TO: Mayor and City Council
FROM: Director of Public Works
SUBJECT: MISSION BOULEVARD CITY HALL SEISMIC UPGRADE: REJECT ALL BIDS AND PROCEED TO RE-ROOF THE BUILDING BY PURCHASE ORDER

ADDENDUM NO. 1

SUBJECT: SEISMIC UPGRADE OF THE MISSION BOULEVARD CITY HALL
22738 MISSION BOULEVARD
PROJECT NO. 6931

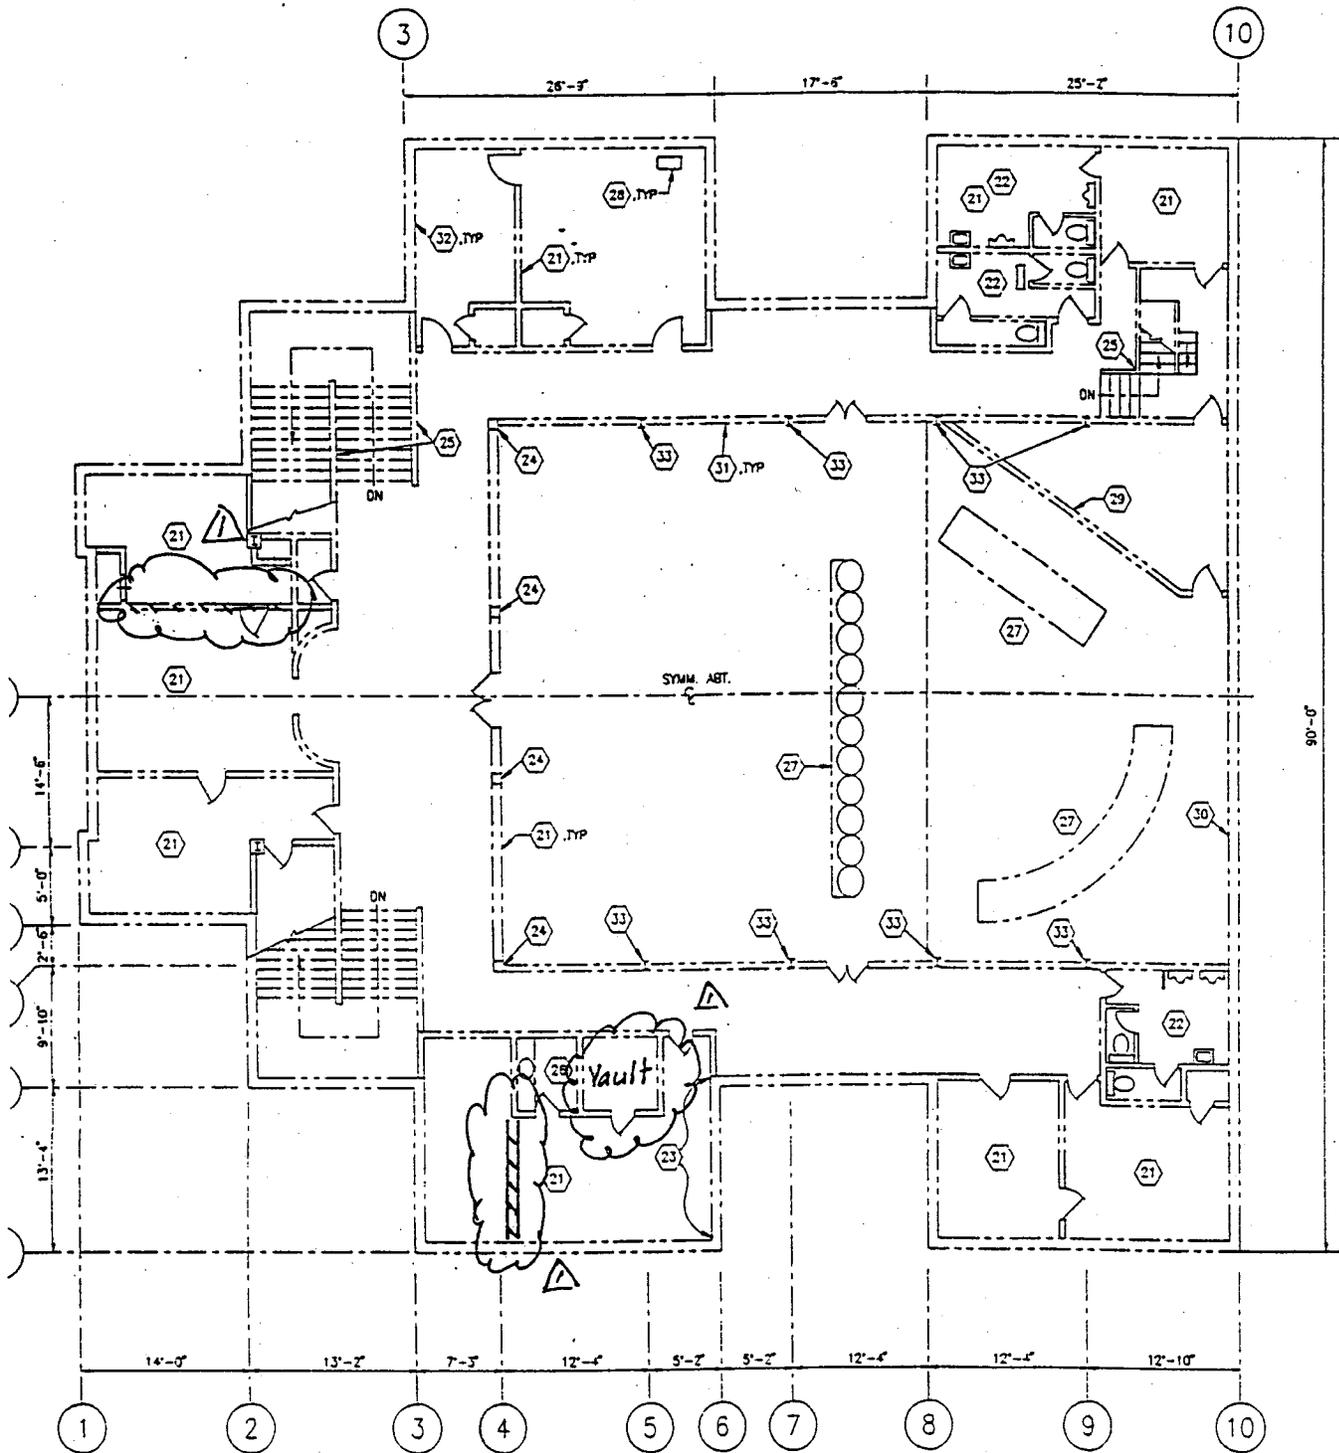
Sheet S1: Asbestos was found in the joint compound on two partition walls on the 3rd floor. One wall is in the west room and one wall is in the southwest room. Sheet S1 is revised to identify the walls. The wall in the southwest room was not shown on the plans. The sheetrock and joint compound will be removed by the City prior to start of construction on this project. The wall framing system will be left for the Contractor to remove.

Sheet S1: There is a vault in the southwest room that is not shown on the plans. The vault is to remain. Sheet S1 is revised to show the location of the vault.

Sheet S1: Third floor demolition note #31 specifies existing wood paneling to be demolished and removed. The City is removing and salvaging some of the wood paneling identified on the plans to be removed by the Contractor. Contractor shall not include salvage value of the remaining wood paneling in his demolition costs.
